SAFETY EVALUATION BY THE OFFICE OF NUCLEAR REACTOR REGULATION

NEDE-32906P, "TRACG APPLICATION FOR ANTICIPATED OPERATIONAL
OCCURRENCES (AOO) TRANSIENT ANALYSES"

PROJECT NO. 710

Figure 1 Comparison of Radial Power Distributions for two Methods used in the Analysis

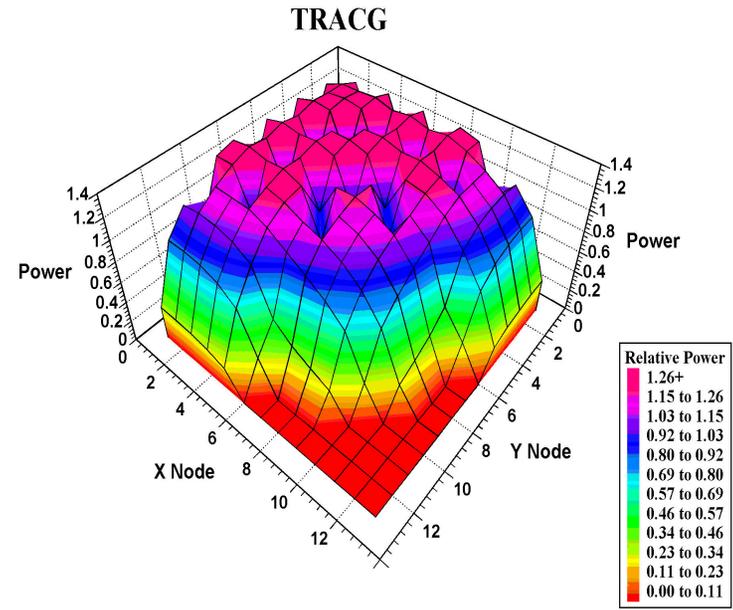
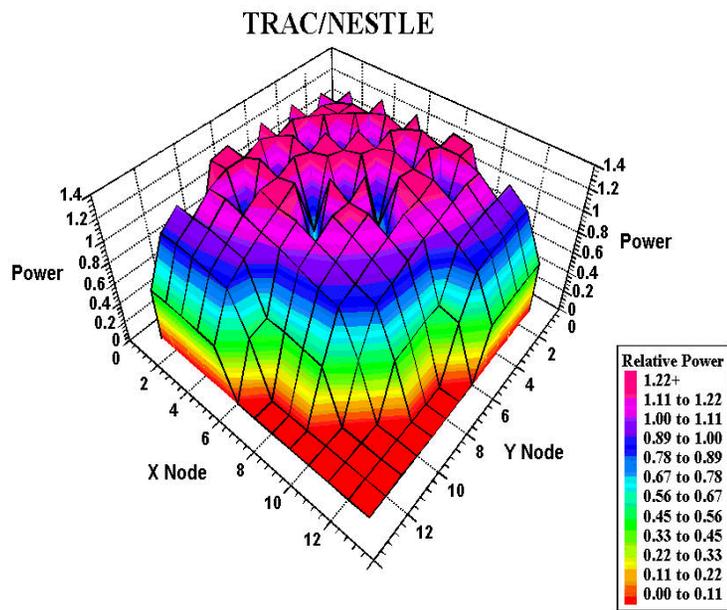
The staff and GNF predictions of the two fuel type core are compared in Figures 1 and 2. Figure 1 shows a three-dimensional view of the initial steady state power distribution and Figure 2 shows the infinite eigenvalue as a function of time for the two fuel types used in the core. One difference between the two predictions in Figure 1 is the fact that the staff results are not as smooth as the GNF analyses. This difference is typical when comparing modern nodal methods to finite difference methods, possibly because nodal methods attempt to more accurately account for inter-assembly gradients. Otherwise, Figure 1 demonstrates that the two methods quantitatively agree well with one another. Figure 2 shows that the void reactivity input into the two respective kinetics codes is equivalent.

Figure 5 Total Reactor Power for Simulated Pressurization Transient

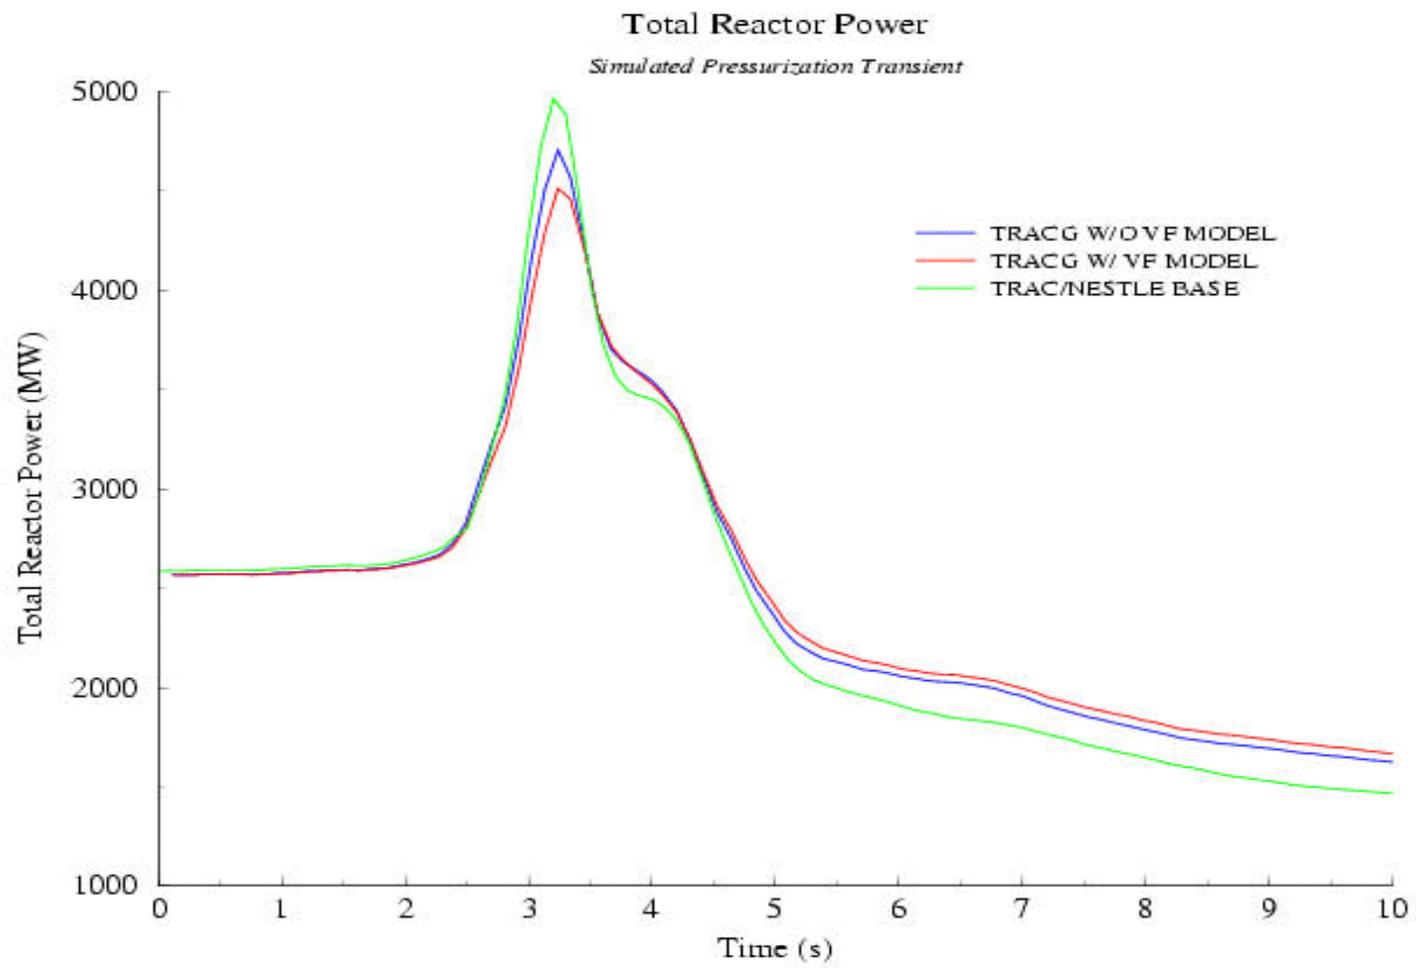
Returning to the discussion of Figure 5, the staff results and the TRACG results are in reasonable agreement. Although the TRACG results without the PIRT18 model agree better with the staff results, the results with the PIRT18 model are acceptable when one considers the following:

1. TRACG compares well with the Peach Bottom turbine trip tests. Although these tests were not as limiting as the transient considered in the test problem and the Peach Bottom core used older BWR fuel that was easier to analyze, the results do provide evidence that TRACG adequately simulates pressurization transients; and
2. The TRACG results, when compared to the staff's results, do not differ significantly enough to affect predictions of $\Delta\text{CPR}/\text{ICPR}$ values. This is true because as mentioned earlier critical power is a function of energy deposition, not power.

Figure 6 Comparison of Different Monte Carlo Evaluations of the Same GNF Lattice

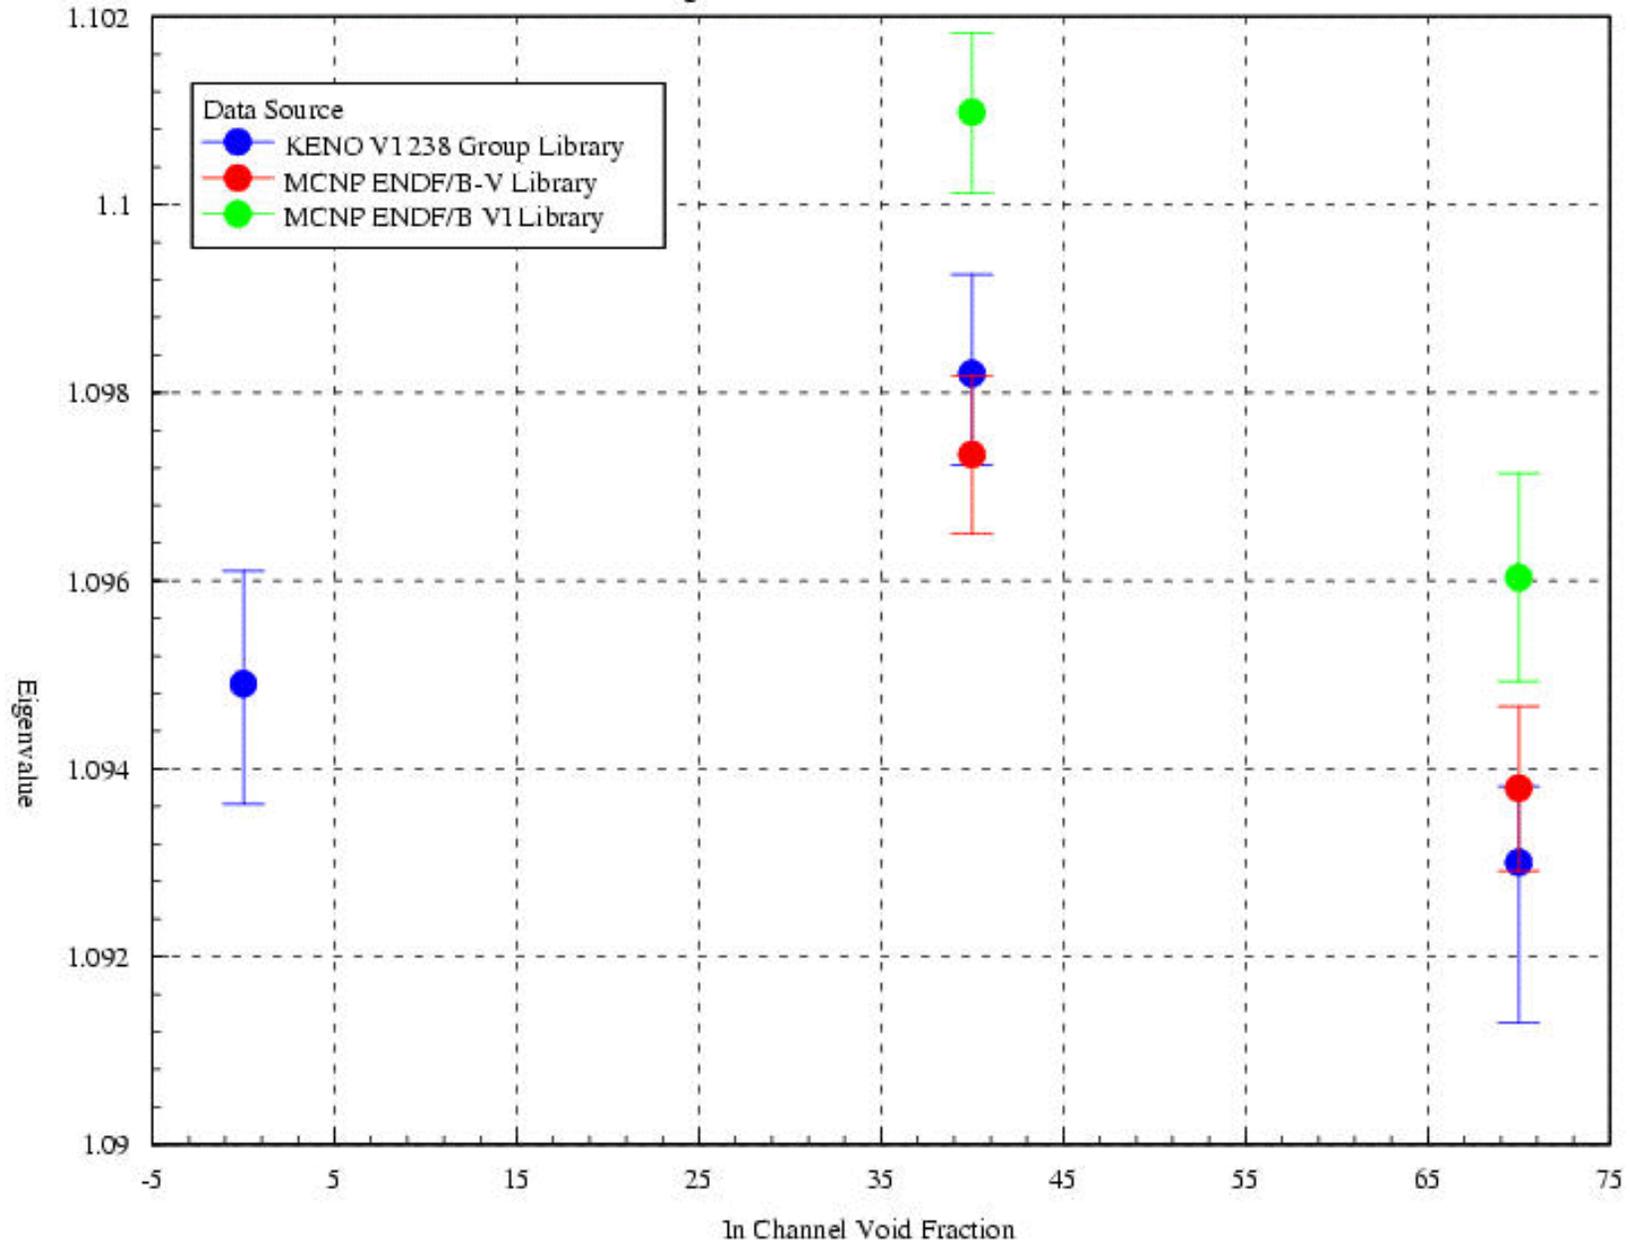
The staff independently assessed this model because the TRACG results are sensitive to it. The staff ran many MCNP calculations of a GNF fuel lattice using different modeling assumptions and different cross sections based on ENDF/B-V and ENDF/B-VI data. The results of the assessment identified a weakness in the GNF model. The GNF model uses the MCNP code, which is a Monte Carlo solver, to predict point values. Monte Carlo methods do not yield point answers; rather, they provide statistically significant ranges of answers. As the staff results in Figure 6 show, a wide range of different, but statistically equivalent answers, can be attained by using different cross section formulations and different (but equivalent) modeling assumptions. The differences presented in Figure 6 would not typically be of concern if it were not for the fact that BWRs are sensitive to void reactivity changes on the order of magnitude of the 95th percentile confidence intervals of the MCNP results.
